Model: Model CM-C2		Date: 14-Feb-08	No.: MG960001
Modified Article: SHEET/LABEL-ONETOUCH		Prepared by: T. Shintani	
From: 1st Tech. Support Sec. Service Support Dept.			
Reason for Modification:	<input checked="" type="checkbox"/> Parts catalog correction <input type="checkbox"/> Vendor change <input type="checkbox"/> Other <input type="checkbox"/> To facilitate assembly <input type="checkbox"/> To improve reliability <input type="checkbox"/> To meet standards <input type="checkbox"/> Part standardization <input type="checkbox"/> Product Safety    (    )

14.OPE Unit (G960)

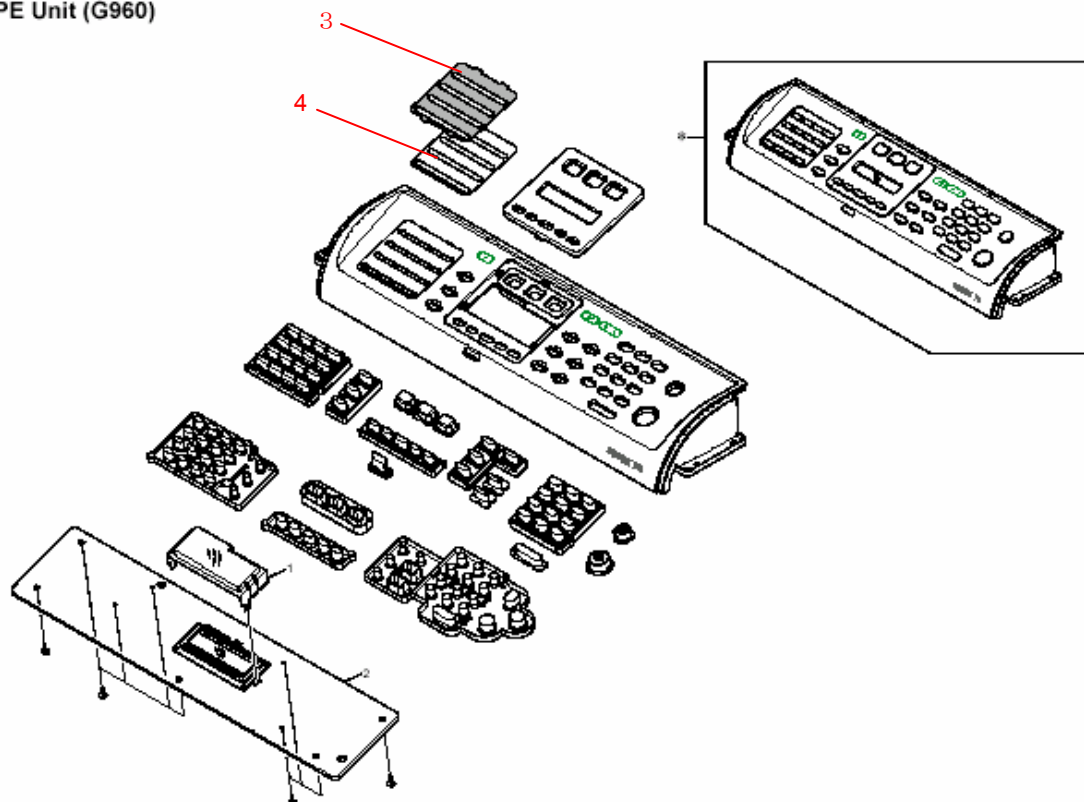
**Change:** These parts were added.

**Reason:** Requests from the field.

NEW Part	Description	Q'ty	Int	Page	Index	Note
G9601292	SHEET-ONETOUCH	1	-	29	3	
G9601345	LABEL-ONETOUCH	1	-	29	4

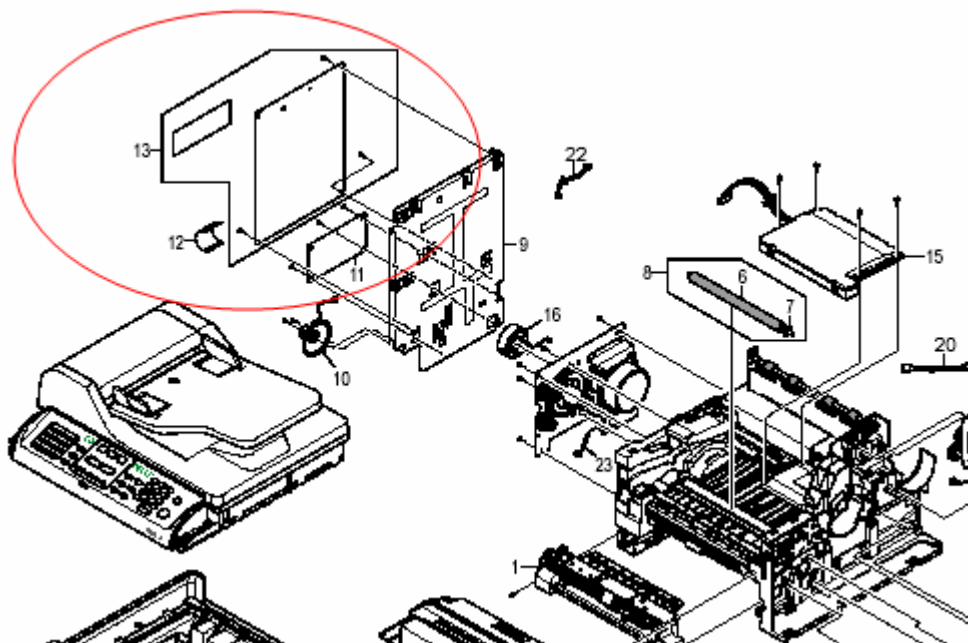
Incorrect Part number	Correct Part number	Description	Q'ty	Int	Page	Index	Note
G9601375	G9601454	Main Board	1	-	3	13

Change/ Reason: Parts catalog correction

## 5.Rear Cover Ass'y (G960)

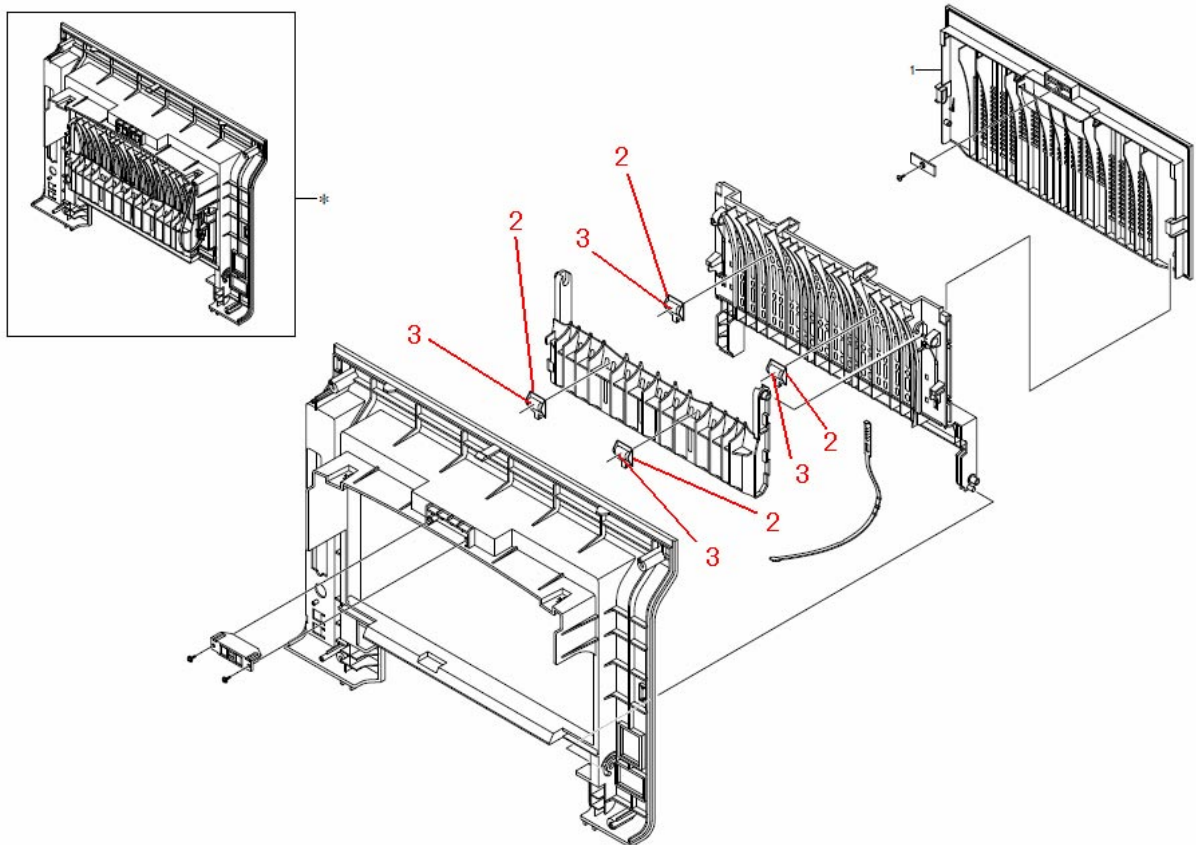
**Change:** These parts were added.

**Reason:** Requests from the field.

NEW Part	Description	Q'ty	Int	Page	Index	Note
G1861222	Idle Roller Holder	4	-	11	2	
G1861223	Idle Roller	4	-	11	3

### 16.Fuser Ass'y (G960)

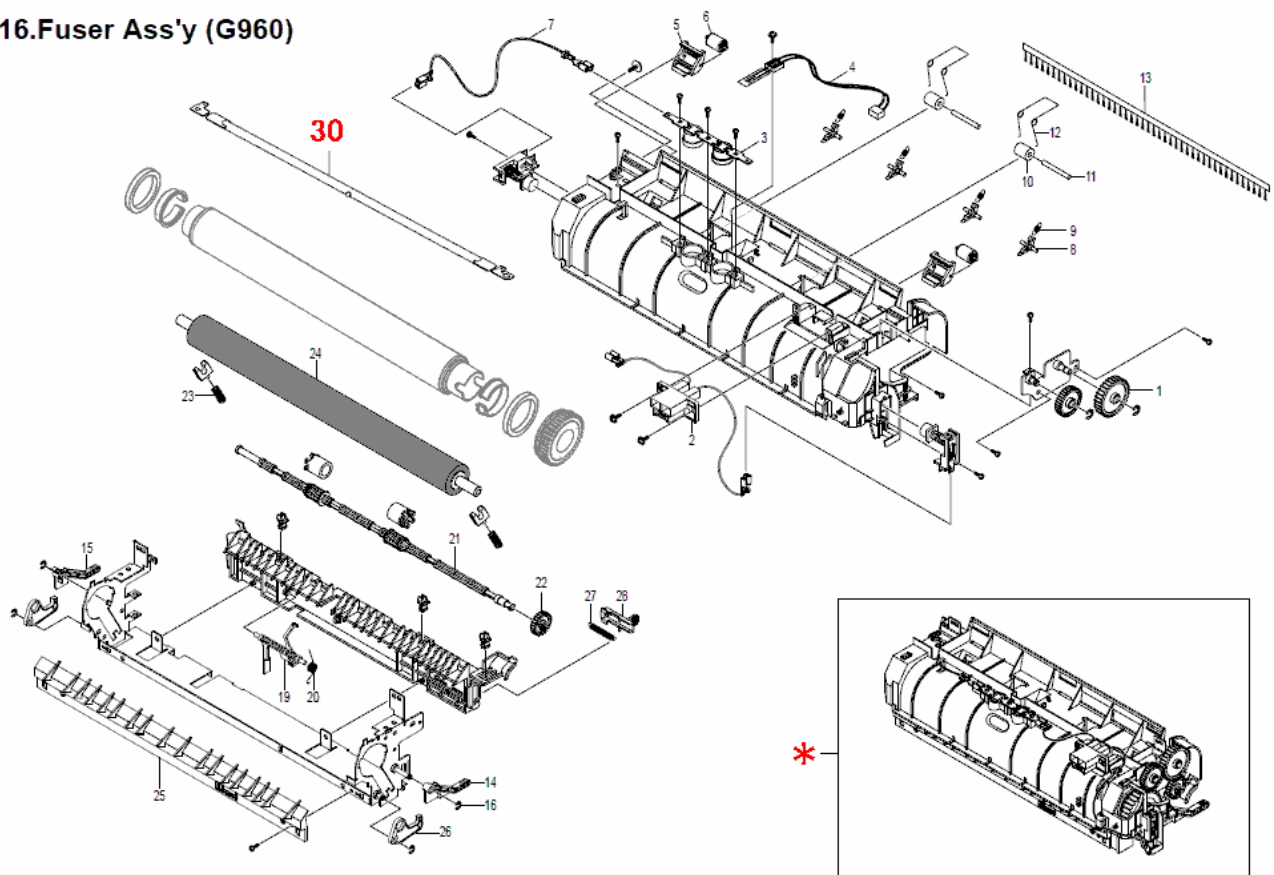
Old part number	New part number	Description	Q'ty	Int	Page	Index	Note
G9601169	G9601600	Fusing Unit – 110V	1	X/O	33	*	
G9601503	G9601602	Fusing Unit – 220V	1	X/O	33	*	
G9601170	-	Hot Roller Ass'y - 110V	1→0	X/X	33	17	
G9601504	-	ELA Unit-Heat 220V	1→0	X/X	33	17	
G9601344	-	Cap	1→0	X/X	33	18	
-	G9601601	Heater 110V	1	X/X	33	30	
-	G9601603	Heater 220V	1	X/X	33	30

**Change:** The fusing lamp was changed from an E-coil type to a Halogen Lamp.

**Reason:** To further minimize fusing temperature variations (minimizing “Low Heat” errors).

When you install the new parts, make sure to upgrade to **System Firmware 1.06.01.00** or newer.
